STATE OF WASHINGTON
DEPARTMENT OF ECOLOGY
1250 W Alder St • Union Gap, WA 98903-0009 • (509) 575-2490

RE: Fresh Fruit Packing Industry Inspection for The Dalles Fruit Company and Underwood Fruit and Warehouse Permit No(s). WAG435290 and WAG435043

FRESH FRUIT PACKING GENERAL PERMIT INSPECTION FORM

Sump pit that includes screens to evaporative lagoon

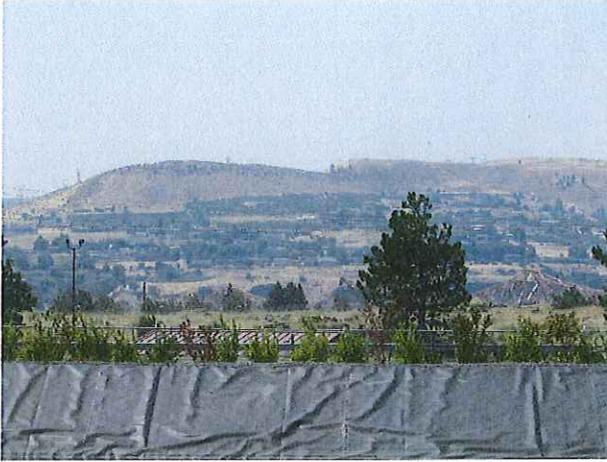
The discharge water goes to an internal pit with screening and prefiltration (water is filtered and reused and then ultimately disposed of); the water than goes to a lined evaporative aerated lagoon and then is metered in a controlled manner to the POTW.
